Meeting 7+8

Comment Discussion

Huawei Technologies Canada

P802.3ck Chief Editor

Figure 120G-2—100GAUI-1, 200GAUI-2, and 400GAUI-4 C2M insertion loss budget at 26.56 GHz

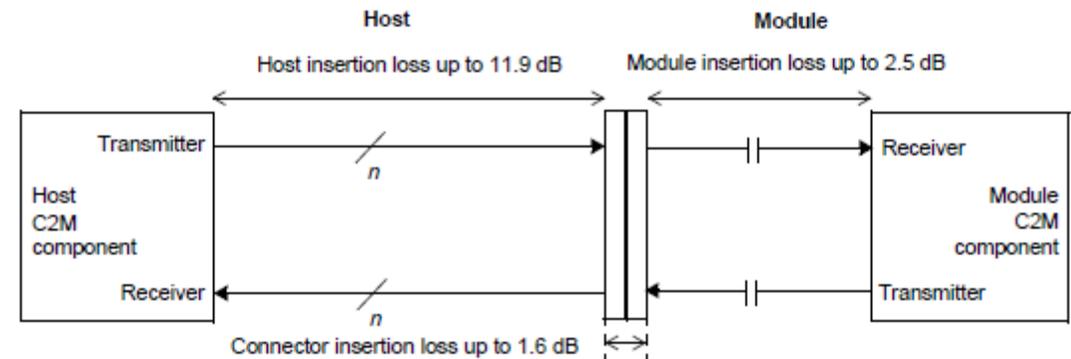
| The figure shows a host insertion loss of up to 11.9 dB, but in 120G.3.4.1.1 (module stressed input procedure) one of the test cases has 18.2 dB insertion loss, which "represents 16 dB channel loss with an additional allowance for host transmitter package loss". The informative graph at 120G.4.1 also looks like 16 dB. | | | | |
| Likely, change the value in the figure to 16 dB. | | | | |

| PROPOSED REJECT. | | | | |
| In Figure 120G-2, the channel loss, which is a sum of the section losses, is 16 dB. | | | | |

It seems that the commenter has misinterpreted the diagram.
